Product Change Notification

1. ECN #: 272753

- HDMR - HDMR FLANGED SURFACE MOUNT SOCKET

- HDMR-19-XX-X-SM-XX-XX

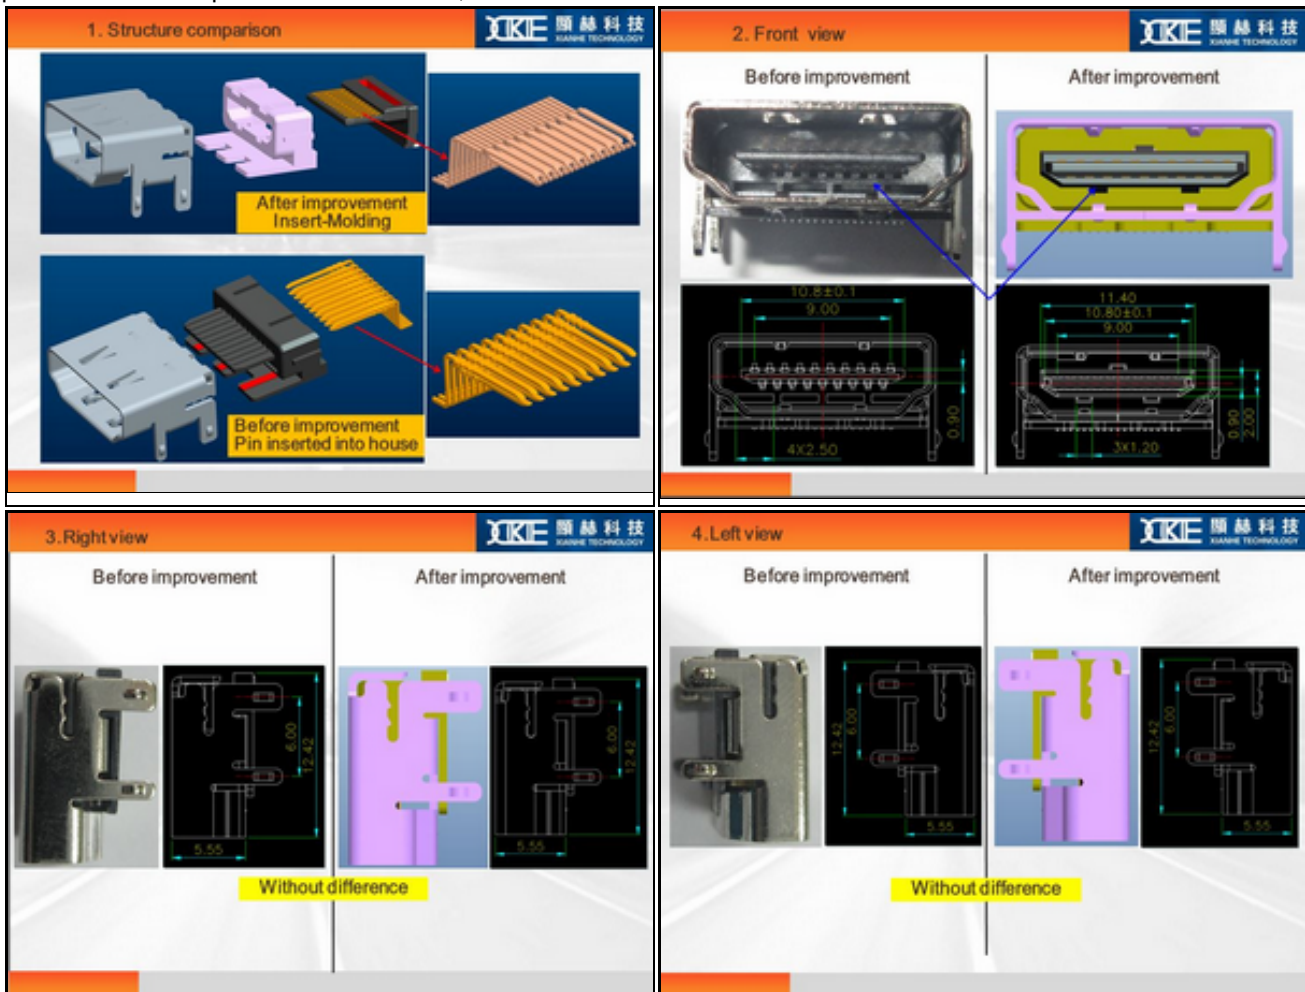
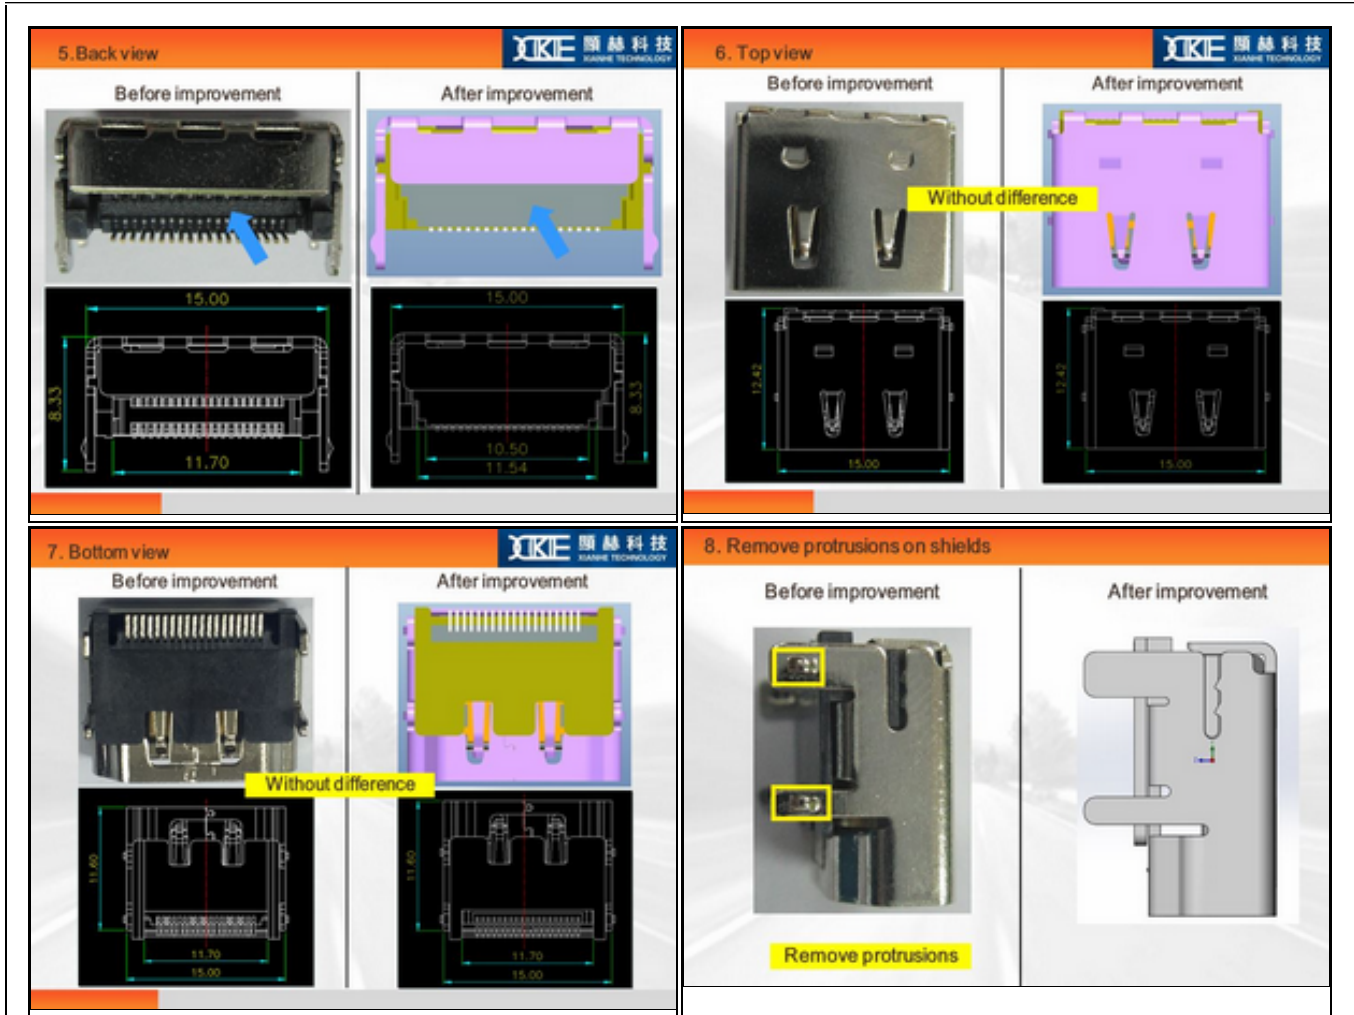
Change assembly method from manual assembly to insert molding process.

Insert molding process assemblies have minor visual difference compared to the manually assembled product. Remove protrusions on shield;

- Form - housing and shields have minor cosmetic differences.
